Executive Director's Recommendation

Commission Meeting: April 5, 2018

South Capitol Street Corridor and Frederick Douglass Memorial Bridge

Approval of comments on concept design for the South Capitol Street Corridor and approval of preliminary and final design for the Frederick Douglass Memorial Bridge

Figure A 1-14 Section E - West Oval - West to East
Scale: 1" = 30'

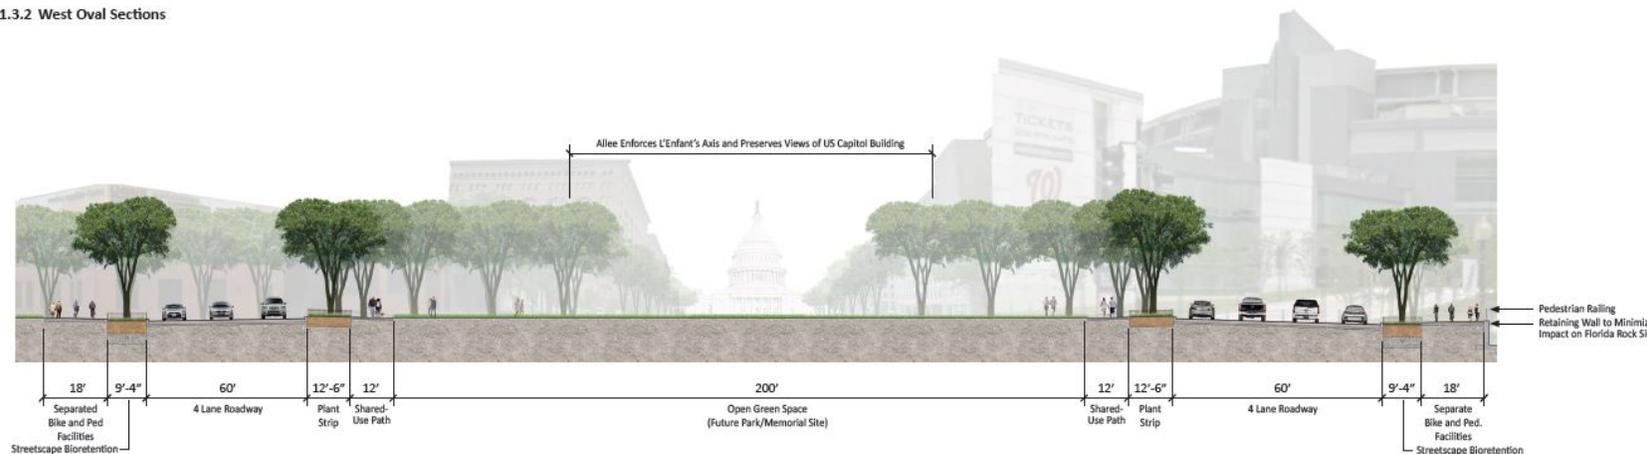
Finds that the South Capitol Street axis is strengthened by the north-south orientation of the park and the landscape elements; however, the Potomac Avenue axis through the oval which is delineated with paving, is less successful because it does not fully align with the cartway.

Requests that the District Department of Transportation explore design concepts (including landscape, paving, and/or additional crosswalks) that better reconcile the change in the Potomac Avenue cartway width across the oval.

Figure A 1-21 Section A - East Oval - West to East
Scale: 1" = 30'

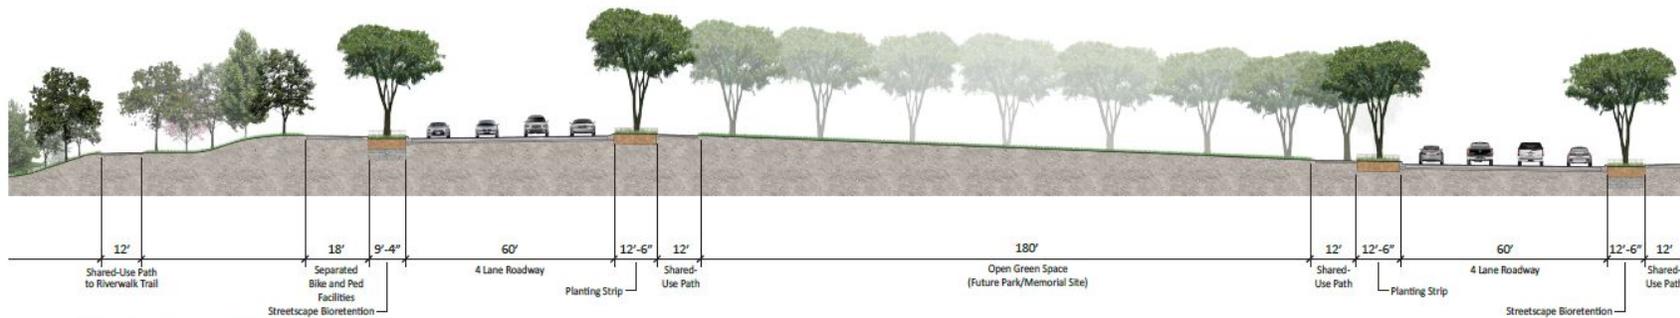
Notes that while pedestrian and bicycle access to this site from the west seems appropriate, the connections from the east, where the future Poplar Point redevelopment is located, needs to be strengthened.

Requests the District Department of Transportation explore a direct pedestrian/bicycle connection to the northeast from the oval, connecting to the proposed traffic island.
